RESIDENCE

7450 NORTH MERCER WAY MERCER ISLAND, WASHINGTON

LBH RESIDENCE

ENLARGED SITE PLAN & MISC DETAILS **SUP-01 (a)**

5 ENLARGED SITE PLAN - Partial

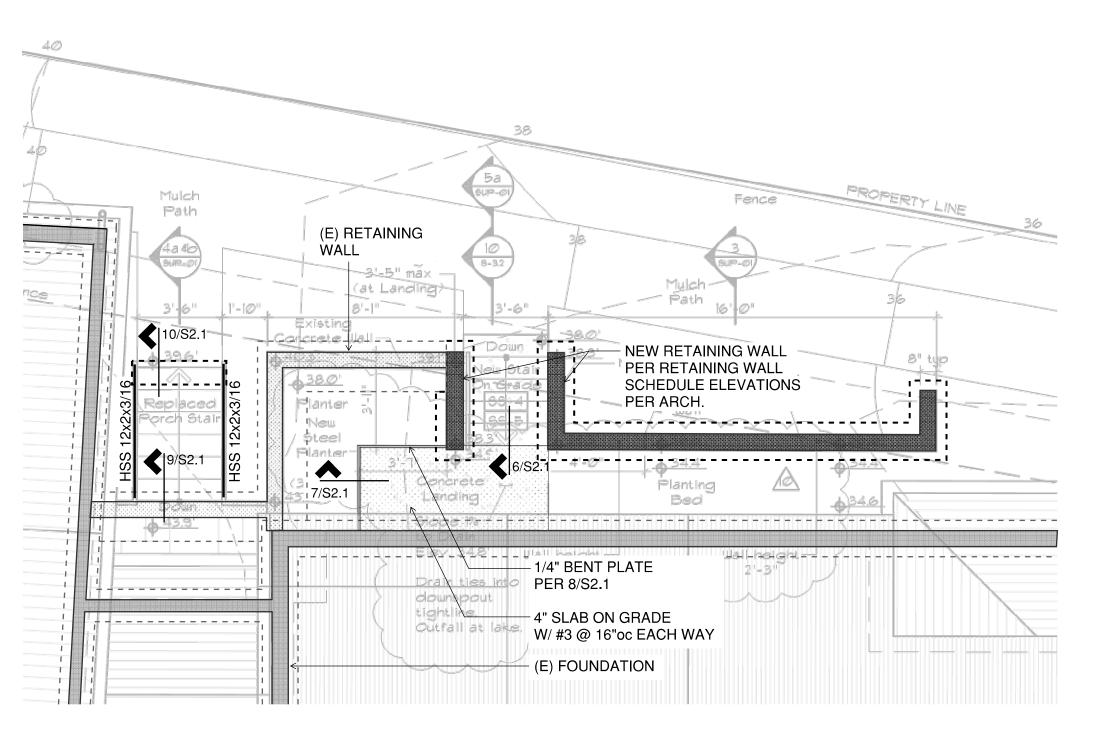
DELETED SEE NEW STRUCTURAL SHEET 52.1 - Detail 9 PORCH STAIR - Top

DELETED

SEE NEW STRUCTURAL SHEET 52.1 - Detail 11

SEE NEW STRUCTURAL SHEET S2.1 - Detail 12

SEE NEW STRUCTURAL SHEET S1.1 - Schedule

SEE NEW STRUCTURAL SHEET 52.1 - Detail 10
